July 2, 2015  
 Alberta Technology Center  
 Owner: The City of Tuscaloosa  
 Owner's Project No: A15-0513  
 Architect: Ward Scott Architecture, Inc.

This Addendum forms a part of the Contract Documents and modifies the original Bid Documents dated June 22, 2015, as noted below.

**Addendum No. 3 - Structural Items**  
**July 2, 2015**

1 OVERALL SITE PLAN  
 1" = 10'-0"

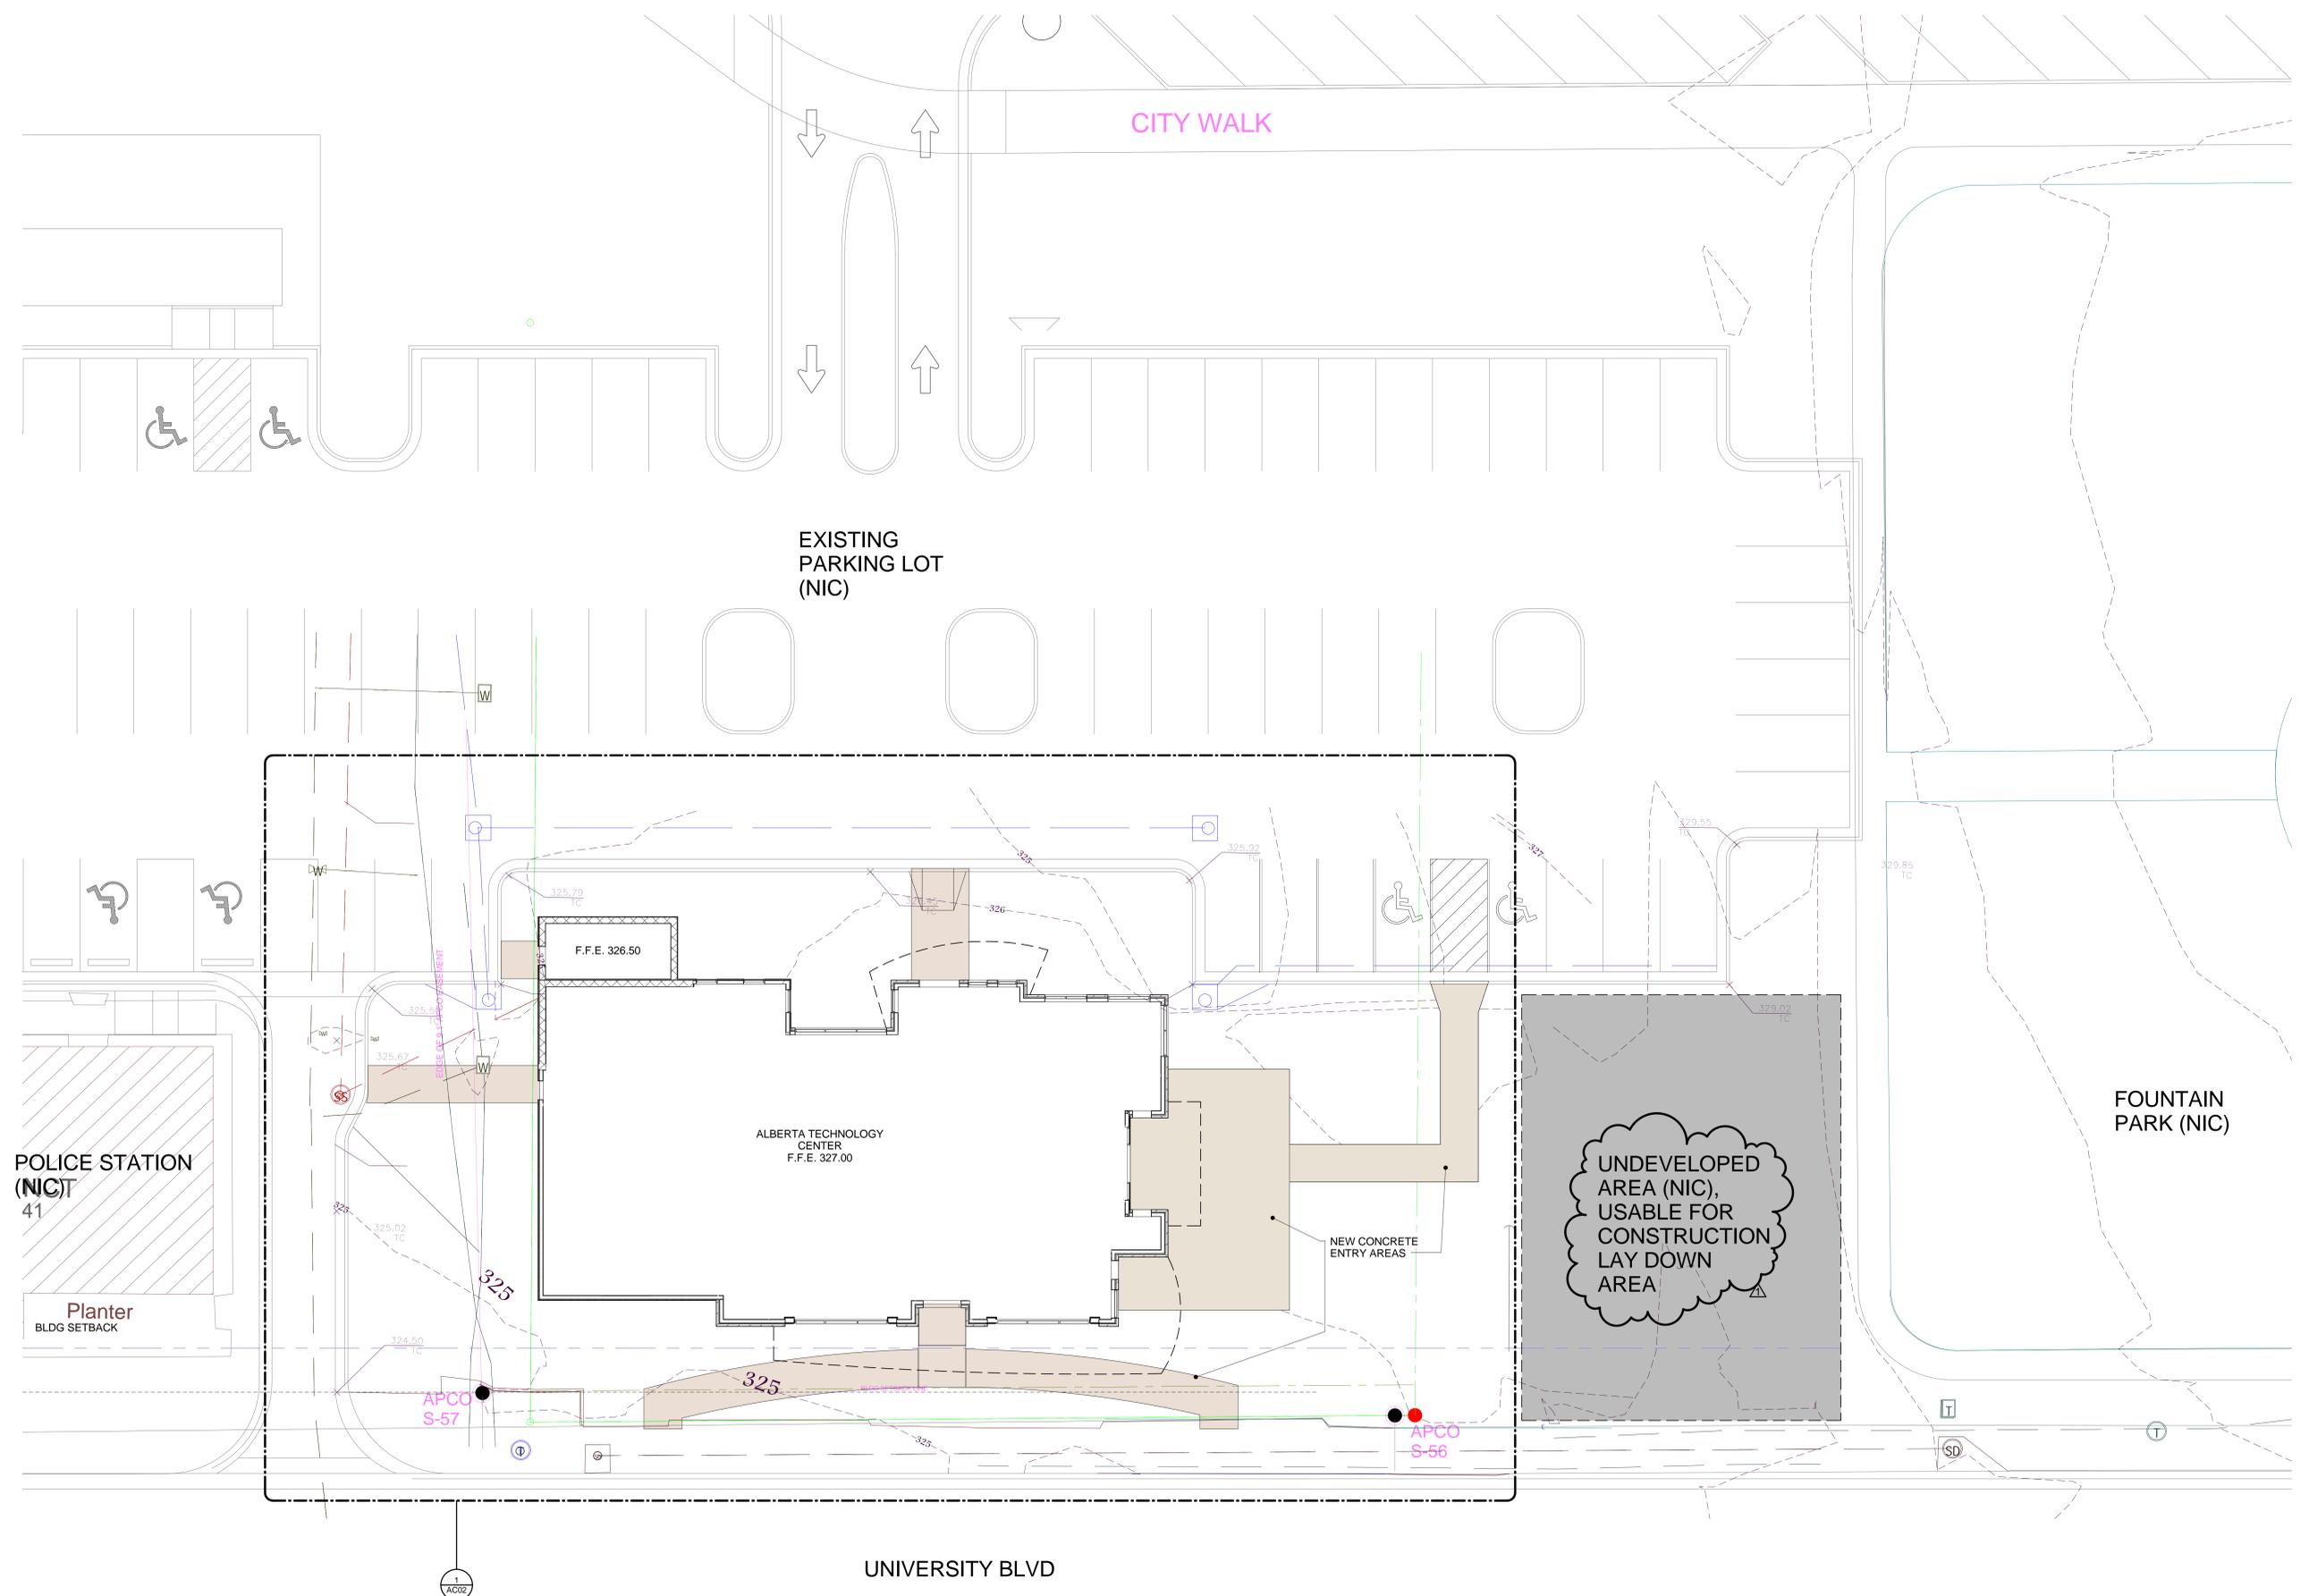
2. AC01 Overall Site Plan. Note west sidewalk has been adjusted north to work with door exit. East side of site (not in contract) will be used for Contractor lay down space in this project.

**A002**

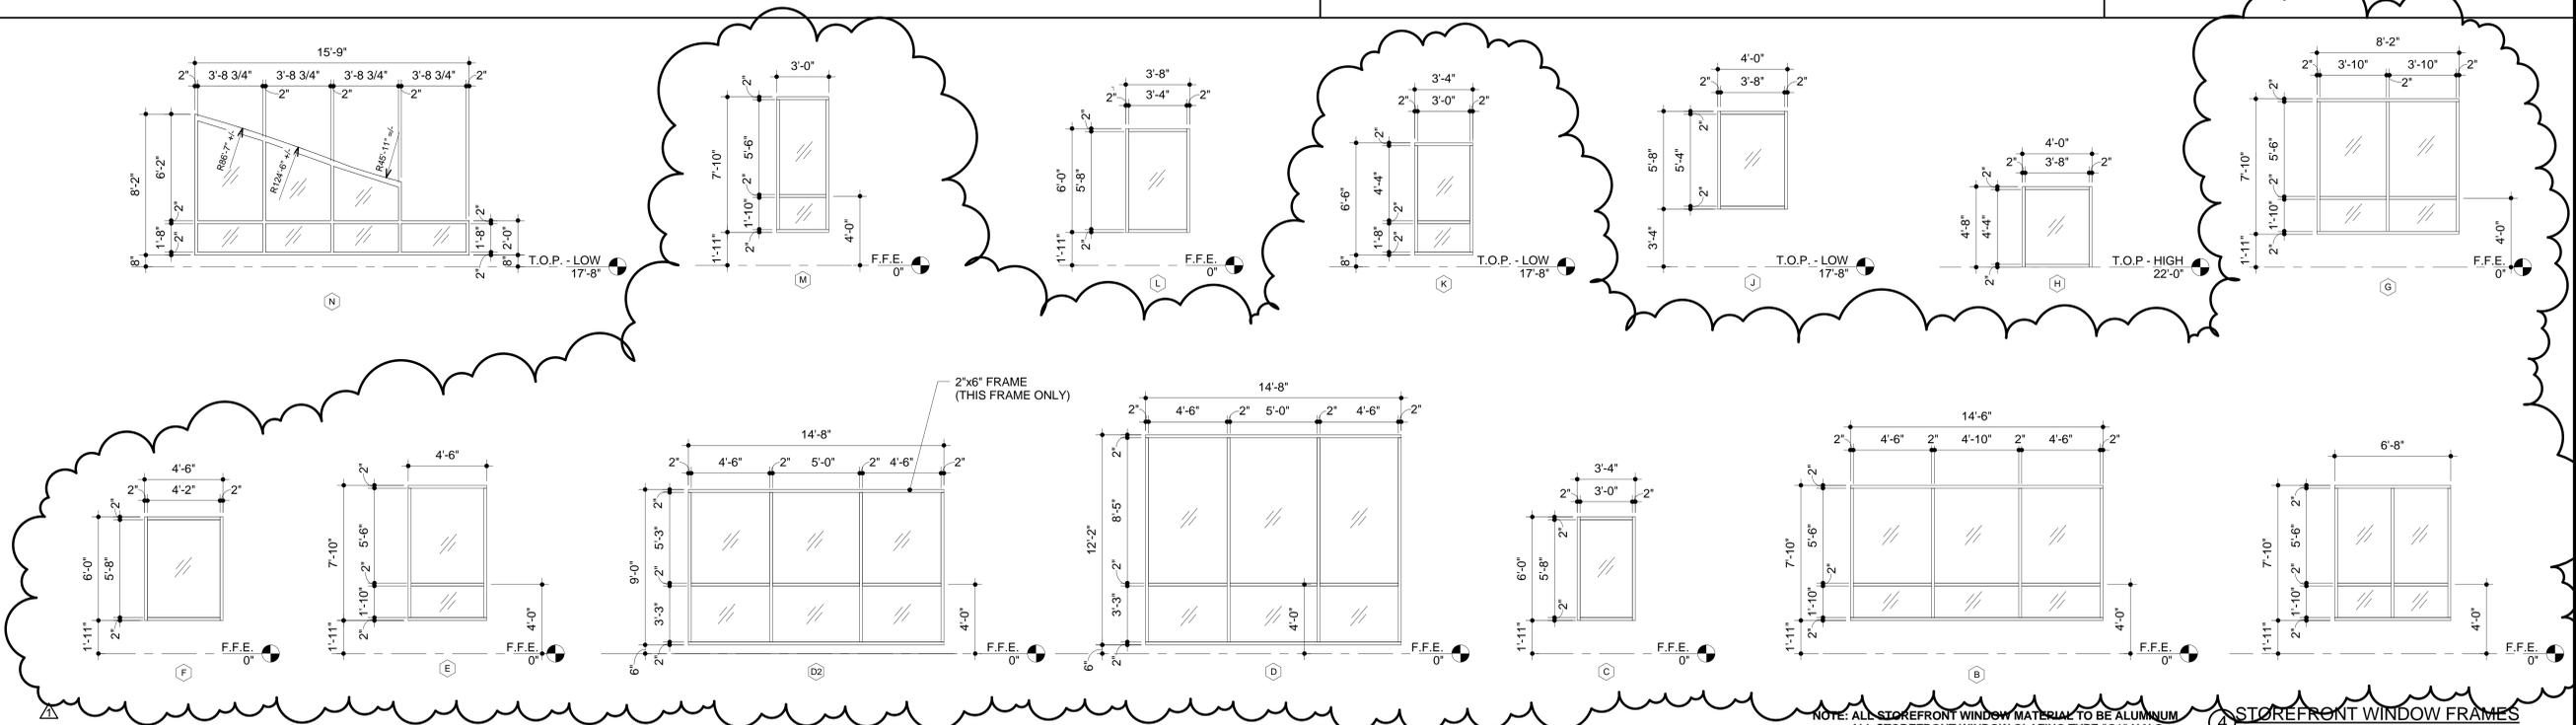
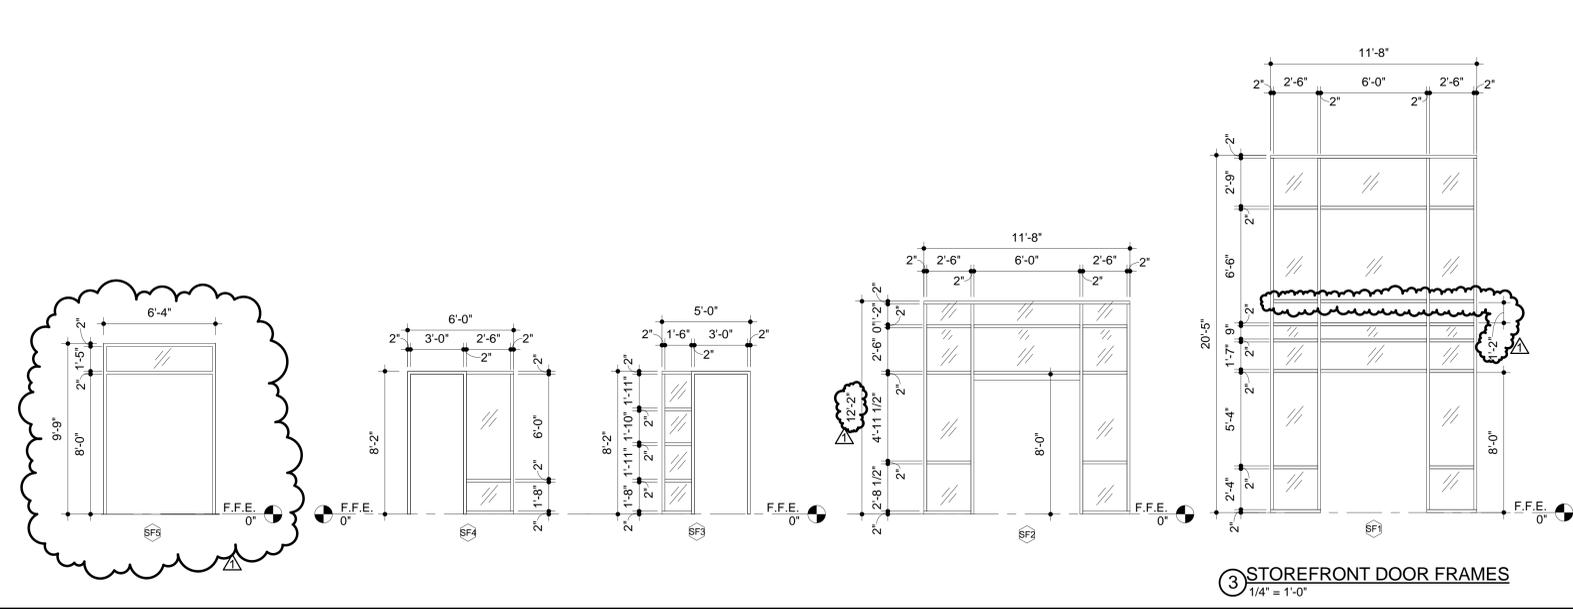
4. A002 Opening Schedules and Details.
    - a. SF1 to have additional horizontal mullion.
    - b. SF2 overall height reduced by 4”.
    - c. SF5 added to include transom over pair of doors.

- d. Storefront frames have been adjusted to “engineer” brick coursing. Horizontal mullions and cast stone headers have been included at standard heights for typical window assembly in masonry walls.

- e. Door 123A – Hardware Set changed to 8A.
  5. A102 Dimension Plan – east exterior wall at exit doors has moved east 7” toward coffee bar. Interior wall adjustments are reflected. All exterior dimensions have been updated to reduce fractions.

3 DETAIL - EAST CANOPY  
1 1/2" = 1'-0"

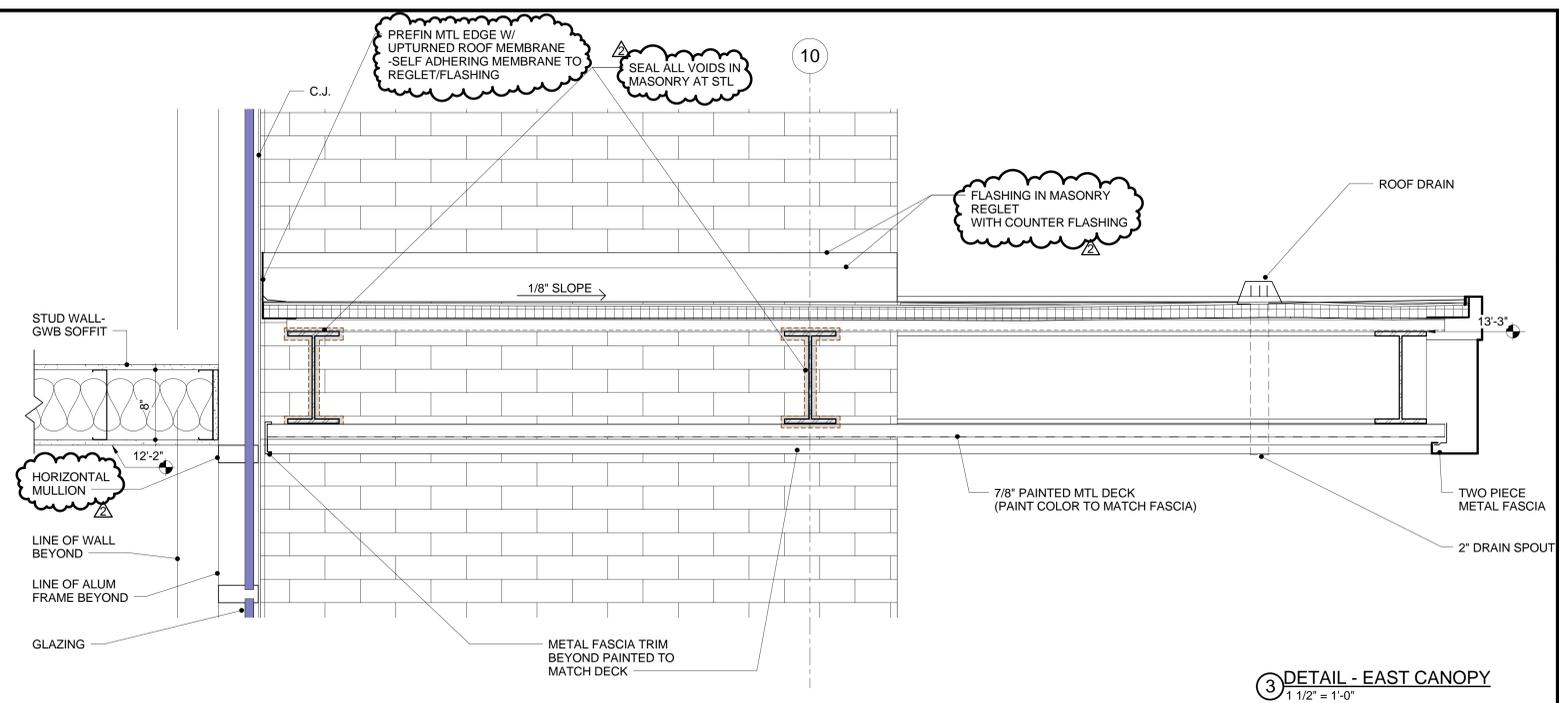
6. A105 Canopy Plan. Detail 3. Additional horizontal mullion shown in SF1. Height of Gyp soffit reduced by 4”. Roofing/reglet flashing info has been added.

**A111**

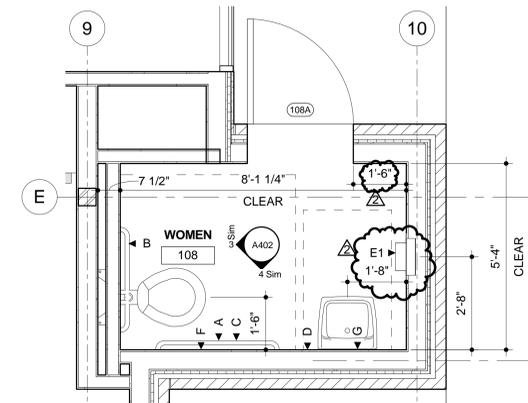
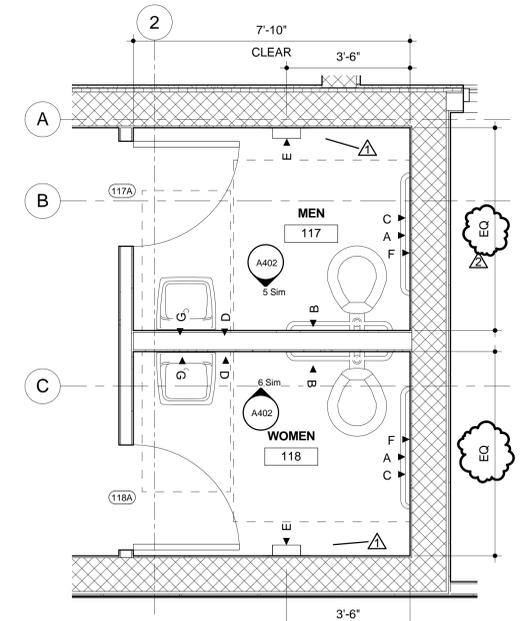
7. A111 Enlarged Floor Plans. Detail 2 and 3. Note Accessory E1 has been added showing recessed fixture, whereas E fixture is not recessed. Note dimensions at Doors 103A and 108A have been added for clarity. Note updated dimension (EQ) at Men 117 and Women 118.

**1 NORTH ELEVATION**  
1/4" = 1'-0"

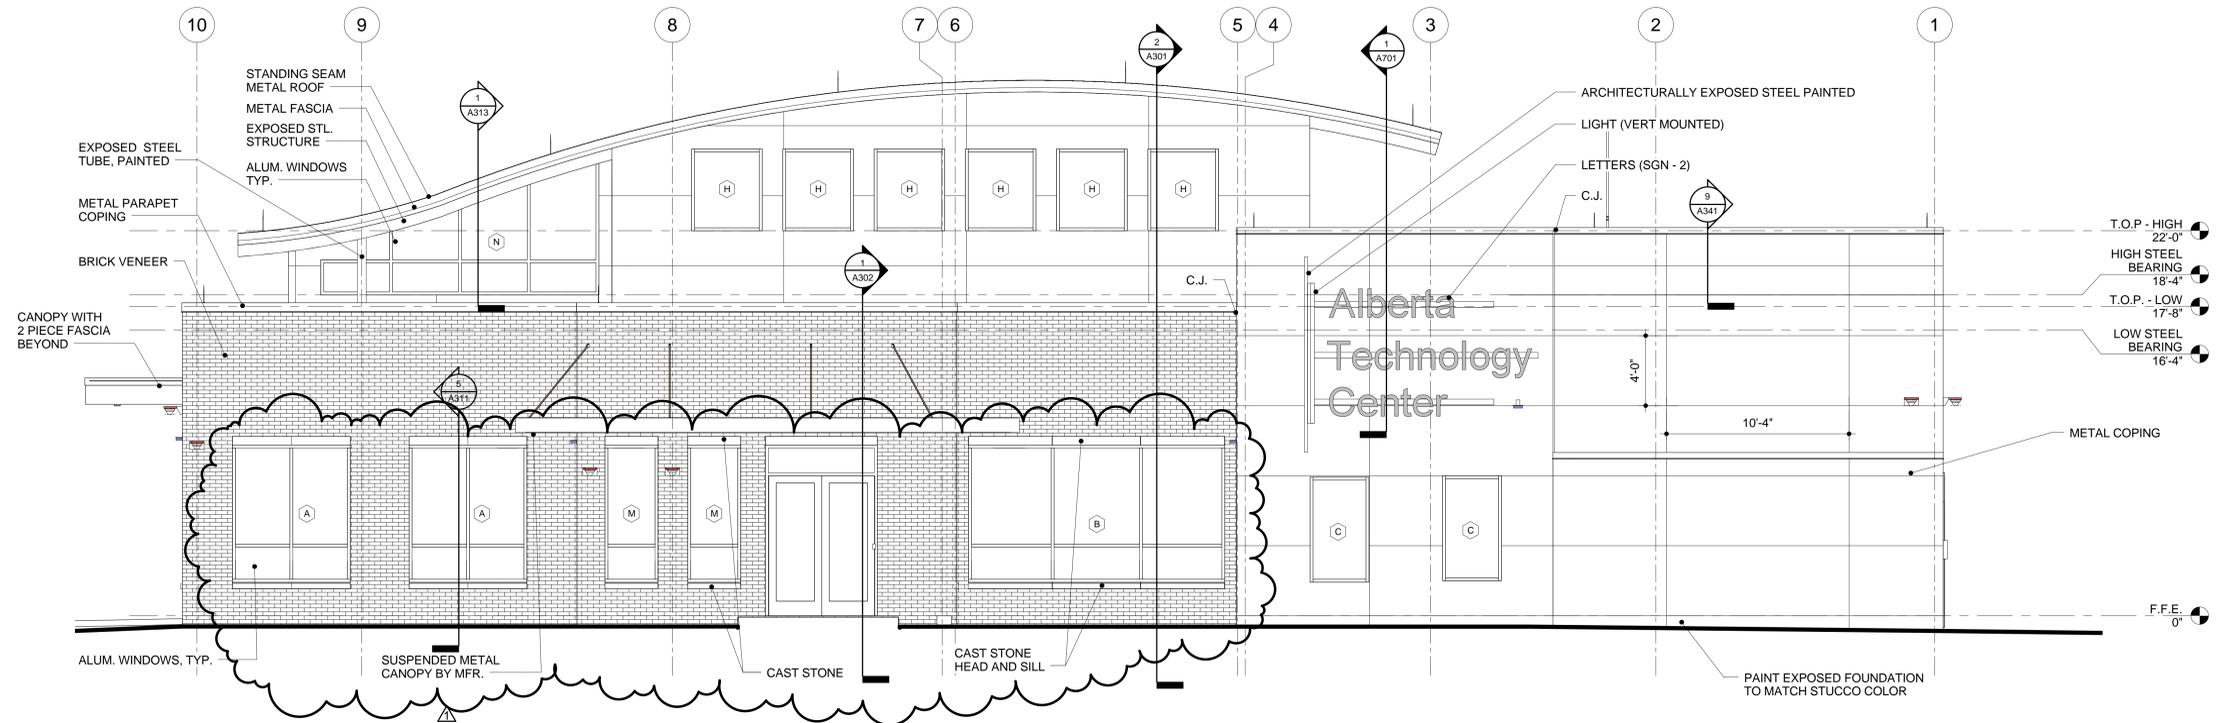
8. A201 Exterior Elevations. Detail 1 - window size adjustments, new door transom and cast stone headers (typical).
9. A202 Exterior Elevations. Detail 2 - window size adjustments, new door transom and cast stone headers (typical).
